CITY OF ALBUQUERQUE

RE: **Lot 18 Block 1 Unit 22 SAD 228 Volcano Cliffs Subd.
8019 Agua Fria Ct. NW
Grading and Drainage Plan
Engineers Stamp Date 10/29/2020 (D10D003N18)
Pad Certification Date: 3/11/2021**

SHEET TITLE: GRADING AND DRAINAGE PLAN

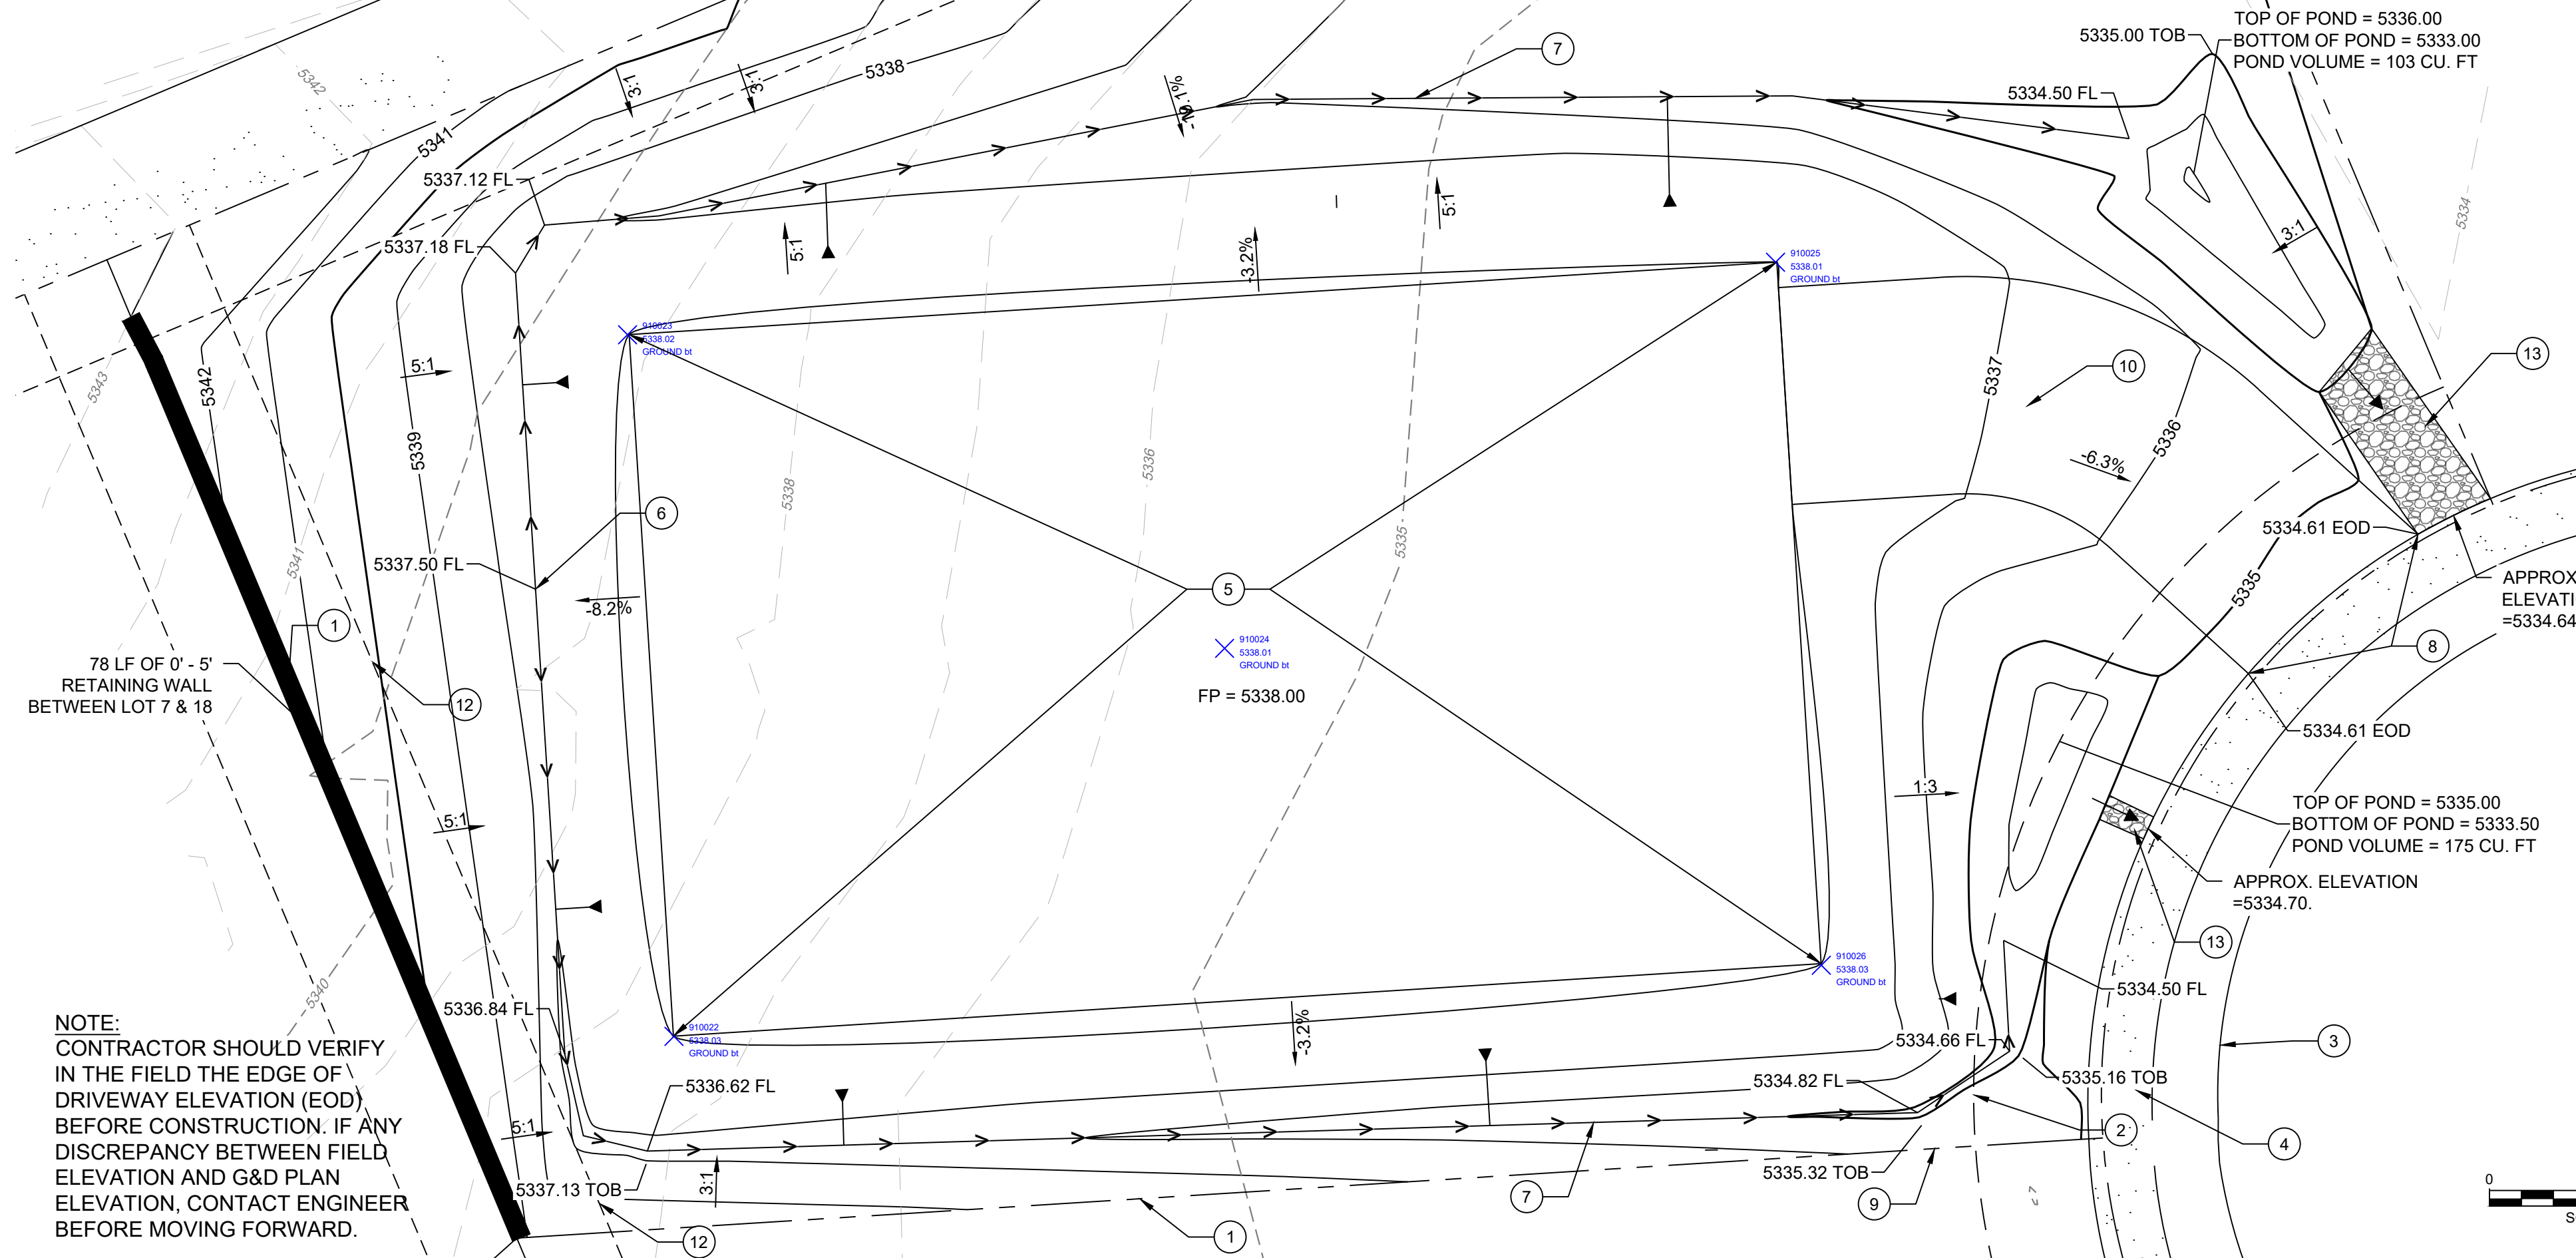
- Remove all dirt from the street. Dirt is not allowed to use as a ramp for going over the curb, only lumber or crusher fines are acceptable.
- Remove the dirt in the channel, it is blocking the flow from Alto Rey Ct. to Agua Fria Ct.

Reiterate to the Owner/Contractor that a separate permit for a garden/retaining wall must be obtained with the approved G&D plan and Pad Certification. **Also, if a swimming pool is to be placed the grading and drainage plan will change and will need to be resubmitted.**
